Value Engineering

Final Report

Grand Valley Irrigation Company Fish Screens

February 28, 2000

Figure 6. Overview Plan Proposal No. 1A.

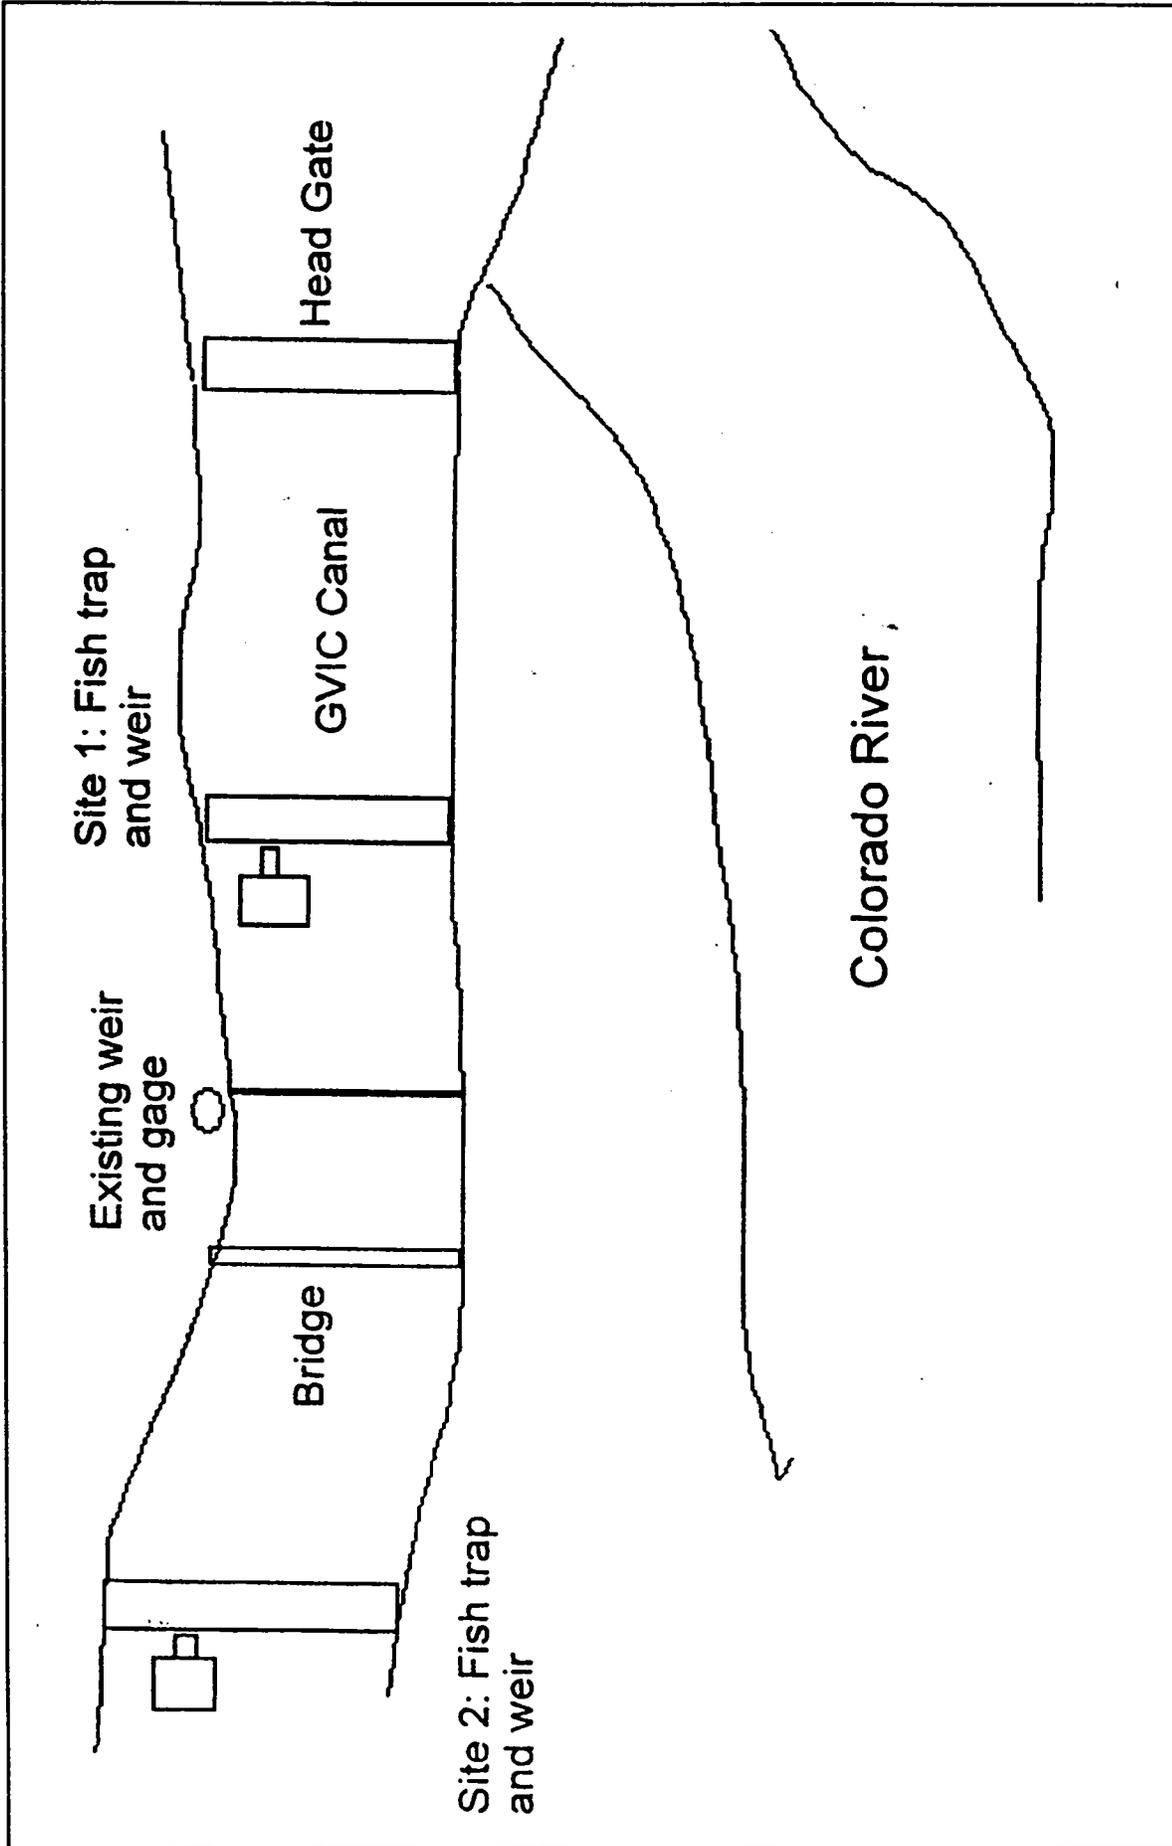
The first screening structure is planned to be constructed in or just upstream of the Grand Valley Irrigation Company Canal (Figure 6). The GVIC wants to work cooperatively with the U.S. Fish and Wildlife Service to protect Colorado pikeminnows and Razorback suckers, but they also must continue to maintain the water supply to their water users. Although U.S. Fish and Wildlife Service biologists argue that it is only a matter of time before endangered fish enter the GVIC canal, water users believe there is not enough evidence to date to justify or support the costly construction of the fish screen structure in the canal. The question is whether to move ahead with the current project based on the limited information or to spend additional time now to collect fish movement data to insure a better design and project success. The Value Engineering Team proposes that additional studies be conducted to collect this information.

- **Ways to Implement:** A study is needed to determine endangered fish movement into the GVIC canal. This can be accomplished by building a small nonpermanent fish weir and trap in the canal downstream of the headgate. Fish can be collected throughout the water delivery season (April-November). This data would then be used to confirm the presence or absence of fish, fish movement patterns, and fish species type, size, and age. In addition, this data could also be used to explore the possibility of using a weir to capture and remove endangered fish from the canal and returning them to the river instead of using a more permanent fish screening structure. Sampling may need to occur during the day and at night, and during different flows and operations times of the head gates. It will cost approximately \$150,000 for the study; \$50,000 for the weir and \$100,000 for two biologists, equipment, and travel expenses to sample the canal for one season.

- **Changes from the Baseline Concept:** This proposal postpones the preferred alternative until further data is collected on endangered fish movement into the GVIC canal. It is hoped that the data will either confirm the need for the fish screens, or provide additional information for refining the current project design and assuring success.

Figure 7. Overview Plan Proposal No. 2.

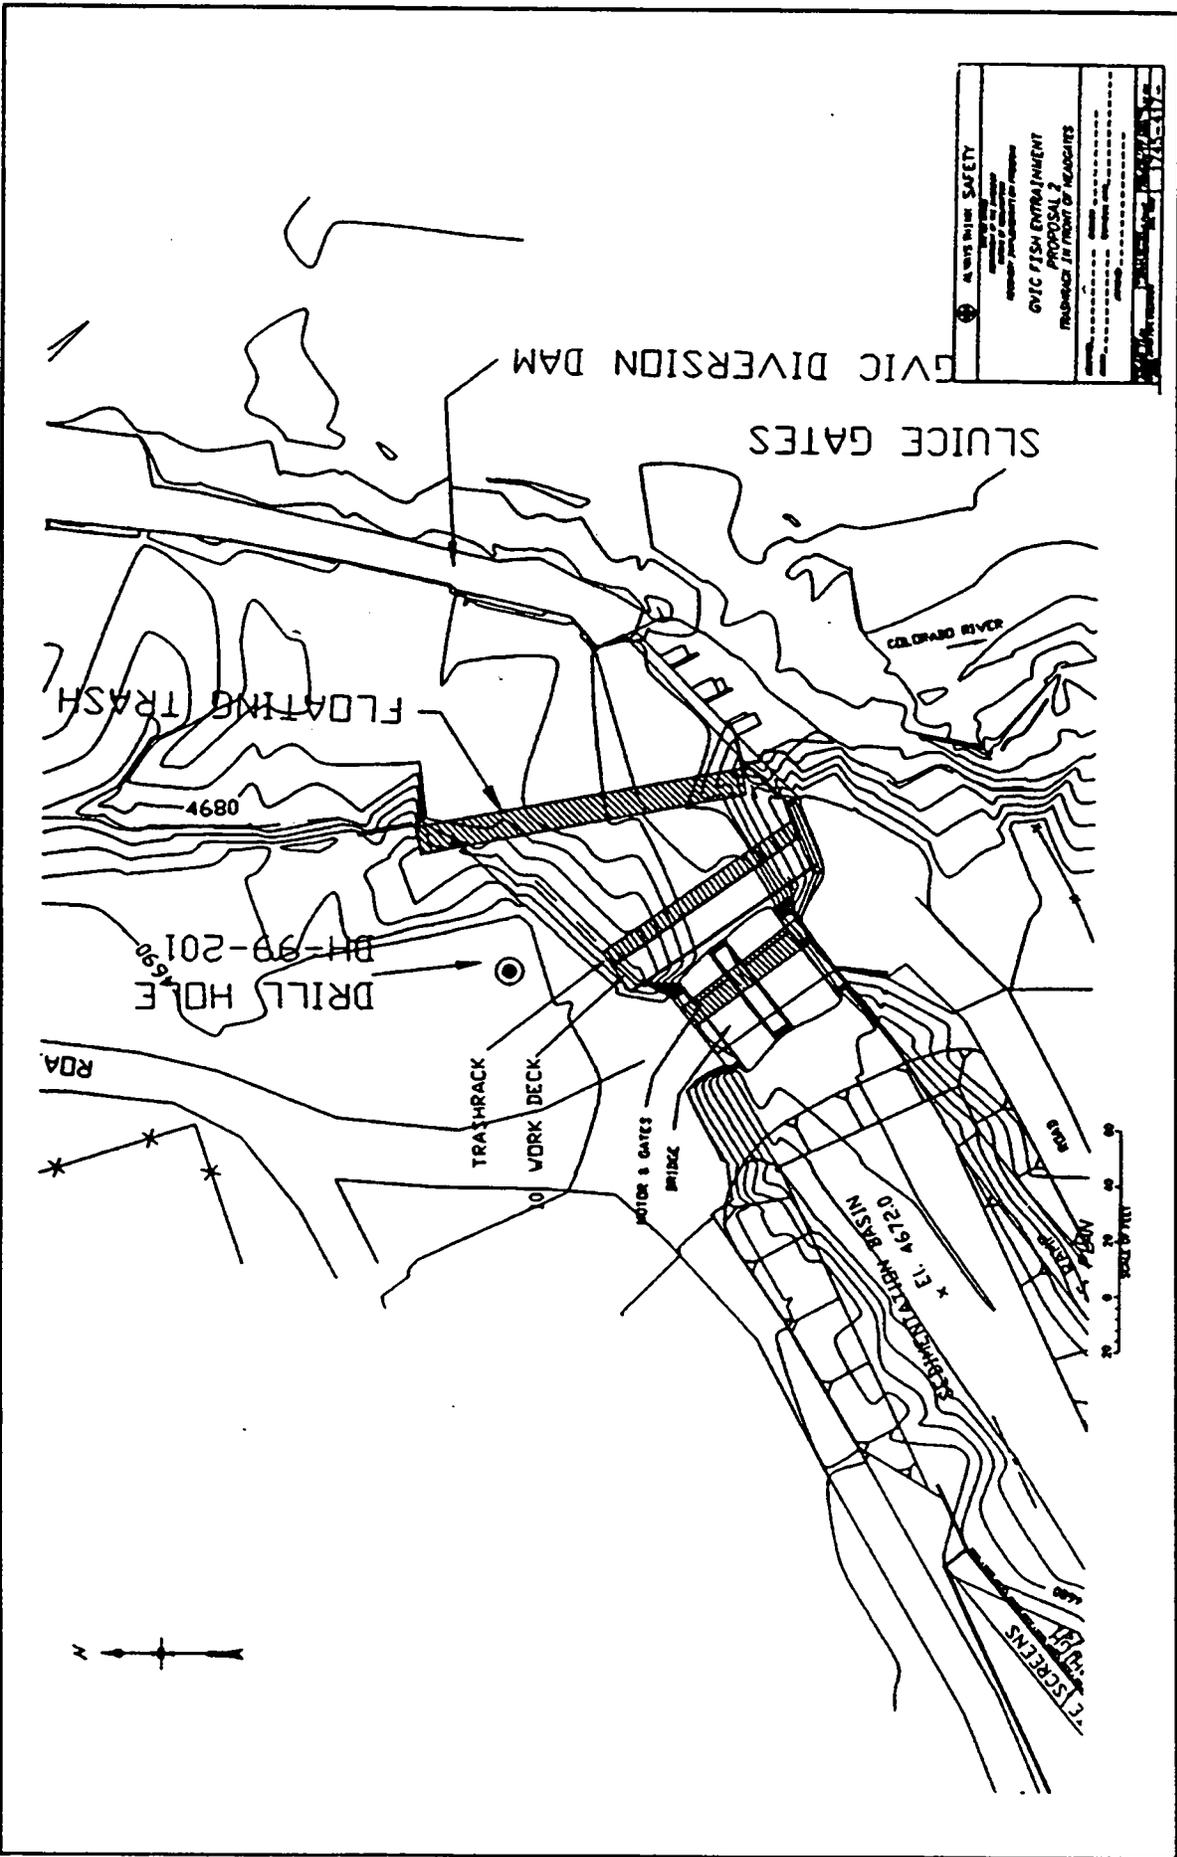
- Proposal Description: Install the trashrack in front of the headgates as shown on Figure 7.
- Critical Items to Consider: 1) In river construction requiring 404 permitting, 2) construction around existing headgates, and 3) cooperate with GVIC to allow alterations to be made to the headgates at the same time. This may permit an adjustment to the location of the sedimentation basin.
- Ways to Implement: Construct cofferdam and install during low water (winter).
- Changes from the Baseline Concept: Remove the proposed trashrack in the canal from the baseline (Option A) and move it in front of the headgates.

- Head loss through the trashrack.
- Possible changes in canal operation.
- Possible changes in flow patterns.
- Possible siltation in front of the headgates.
- Possible added congestion around existing headworks.
- Trashrack may impact headgate operations.

Figure 8. Overview Plan Proposal No. 3.

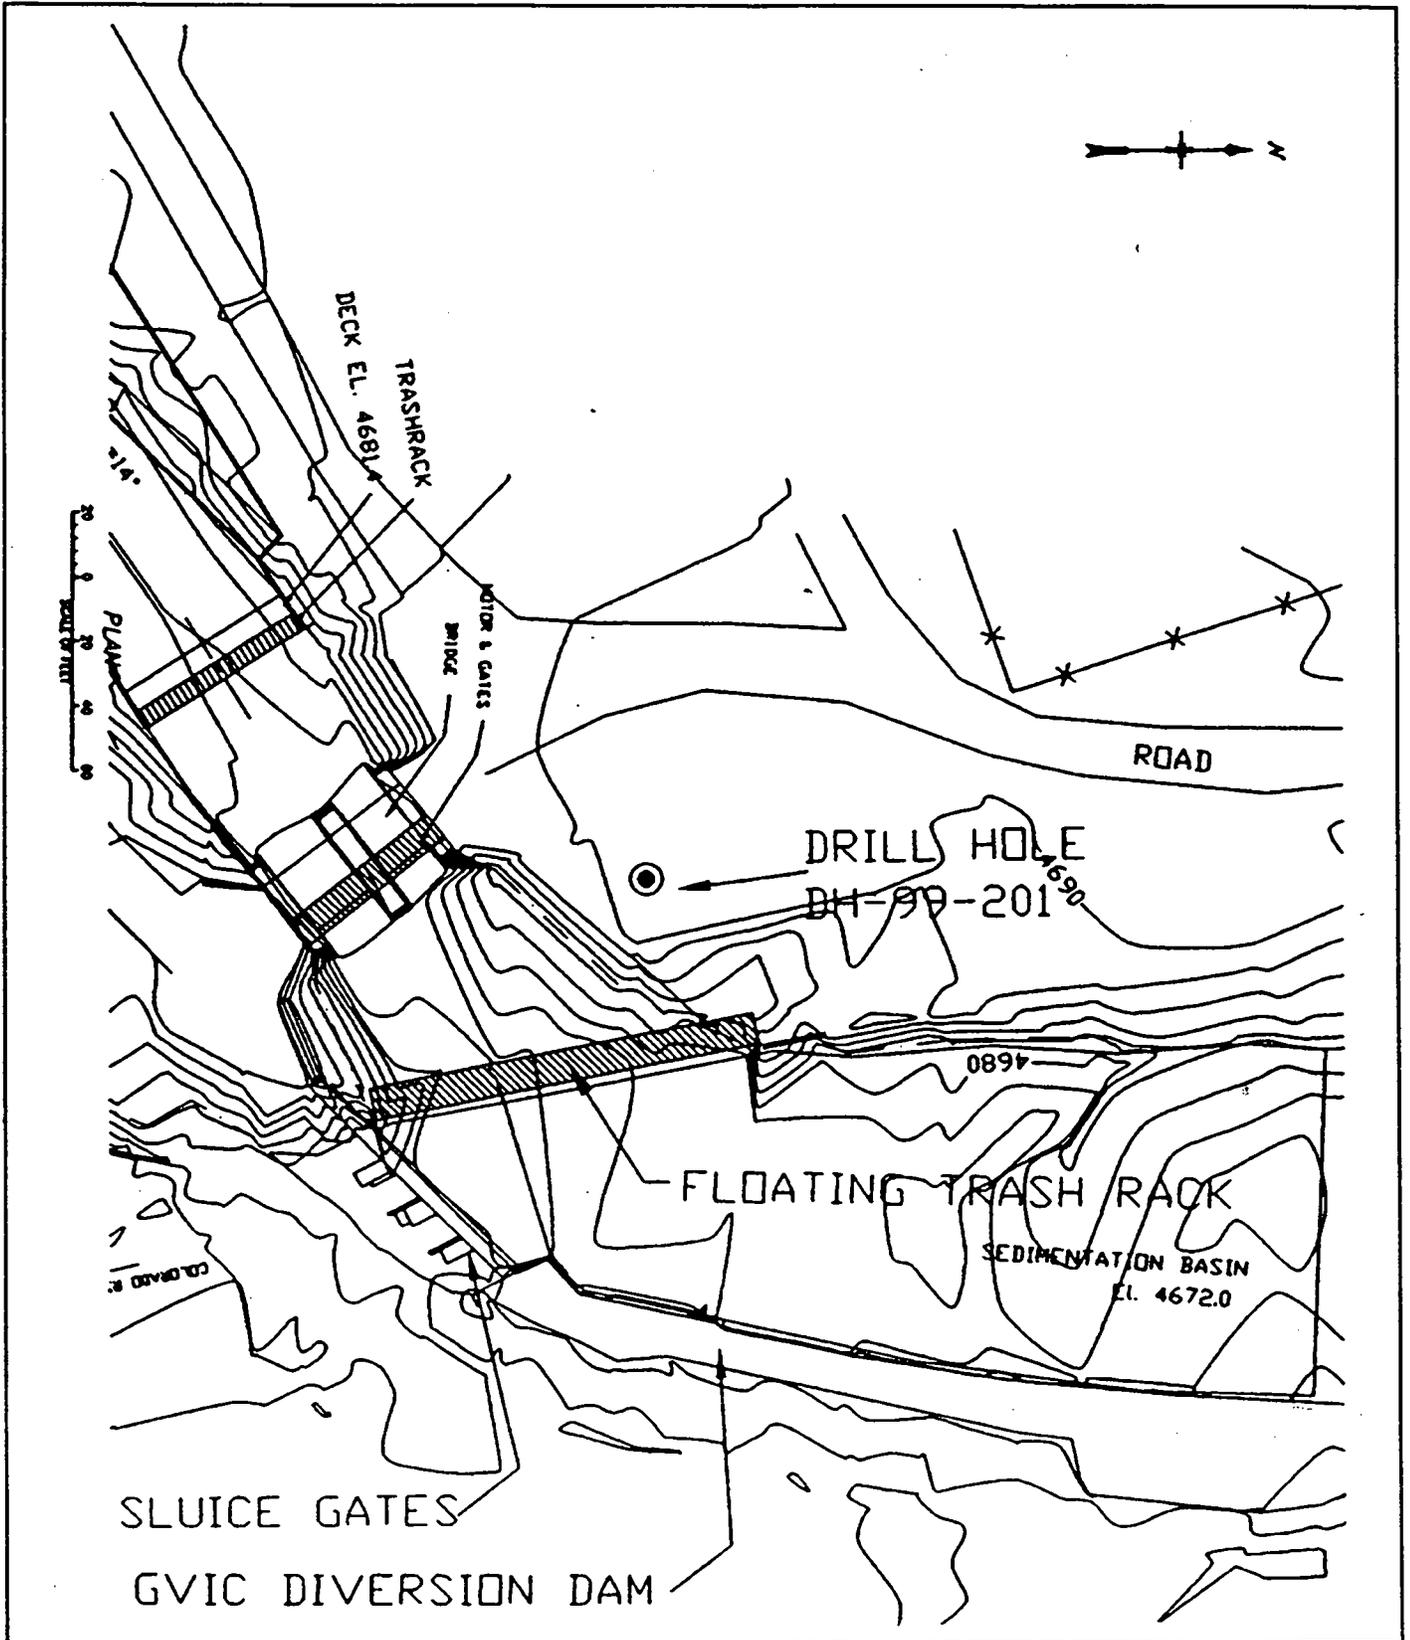
- Proposal Description: Build a sedimentation basin upstream of the diversion dam with sluicing capabilities, as shown in Figure 8.
- Critical Items to Consider: 1) In river construction with 404 permitting required, 2) cofferdam at low water construction (Winter construction), 3) if the flow capacity and drop of the floodgates was increased, this would improve the sluicing of the proposed basin, and. 4) some sediment would probably still have to be removed from in front of the fish screen.
- Ways to Implement: Cofferdam and divert river upstream, excavate basin.
- Changes from the Baseline Concept: Moves sedimentation basin out of the canal. Shortens footprint of the baseline (Option A) structure.

Figure 10. Overview Plan Proposal No. 5.

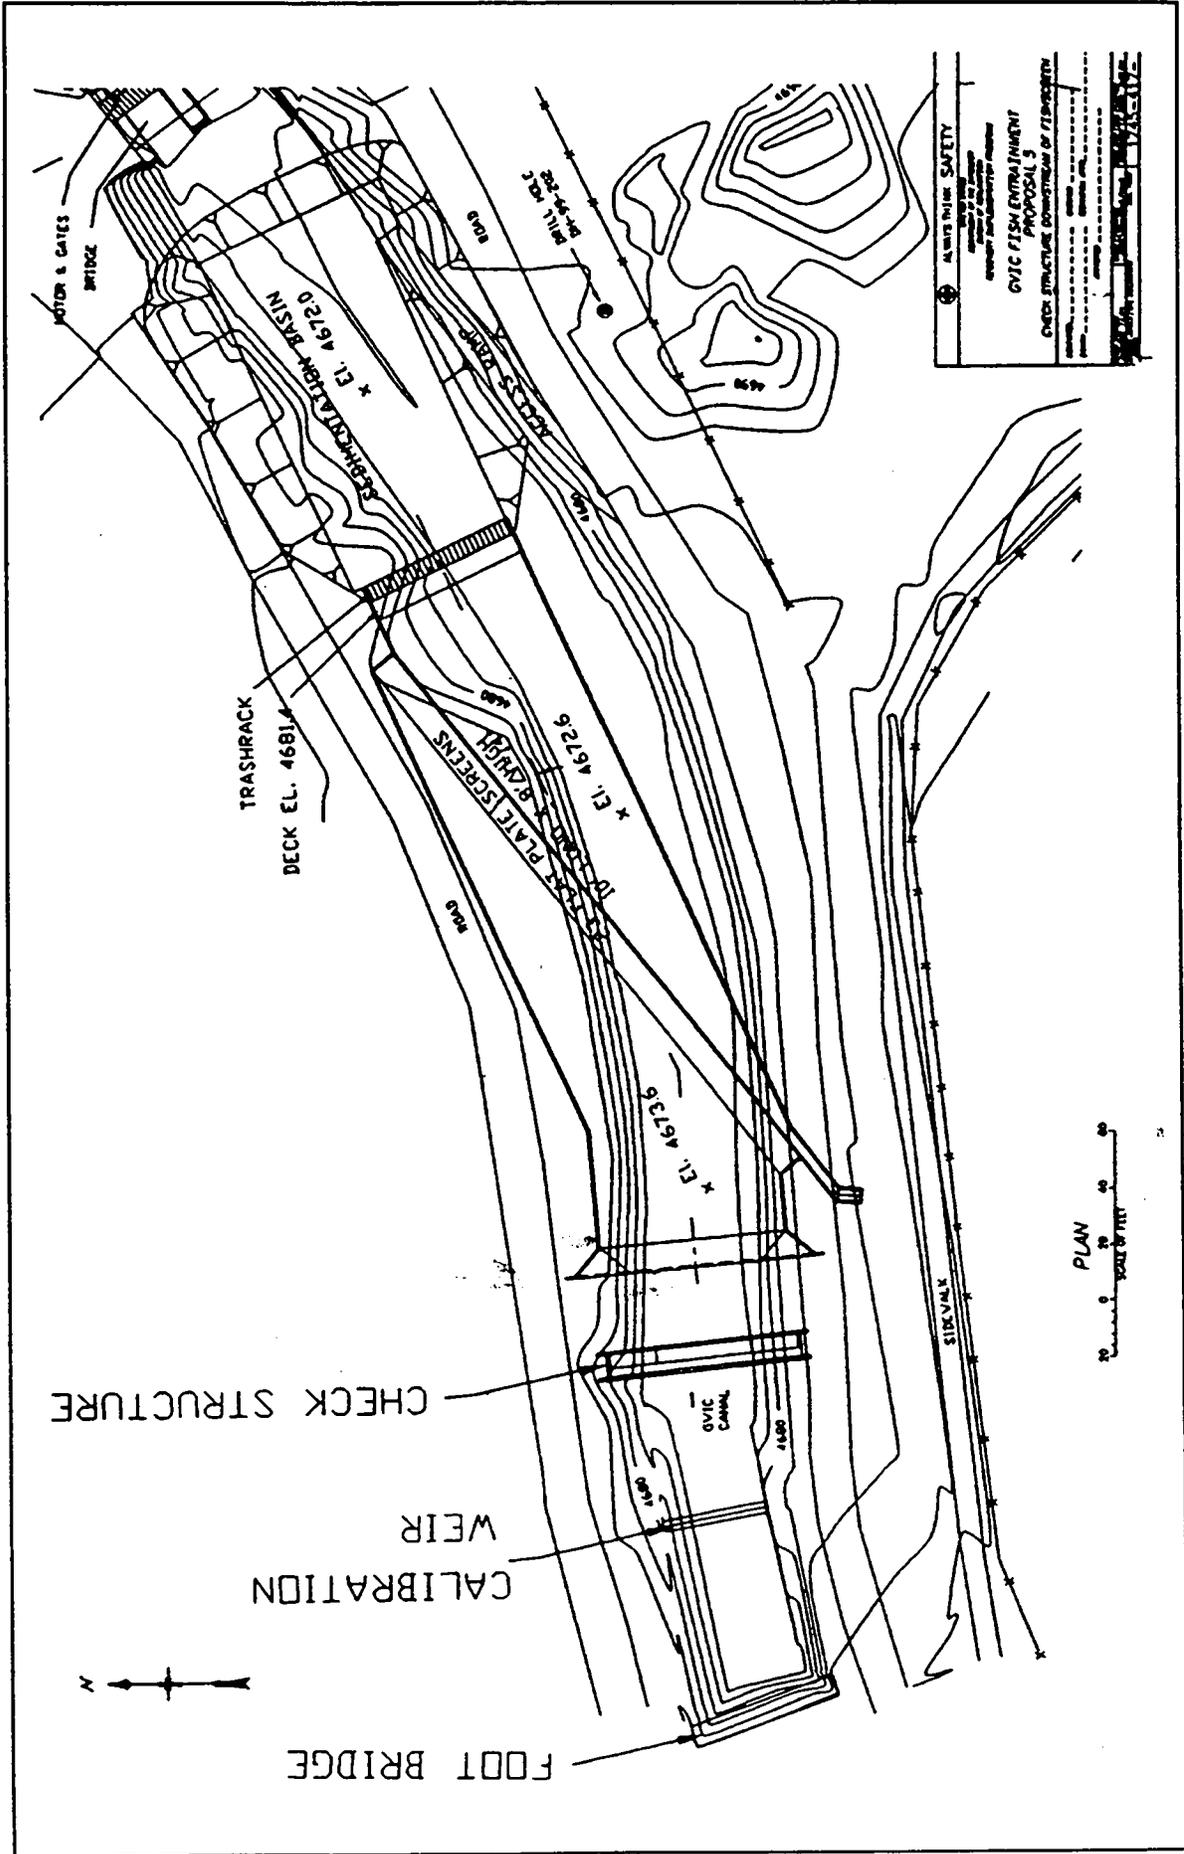
- Proposal Description: Install a stoplog check structure to check head to allow the baseline fish by-pass to operate at high river flows (approximately 20,000 cfs). See Figure 10.
- Critical Items to Consider: Effects on GVIC canal operations.
- Ways to Implement: Construct check structure just downstream of baseline structure in the canal during winter shut down.
- Changes from the Baseline Concept: Adds another structure to the baseline concept.
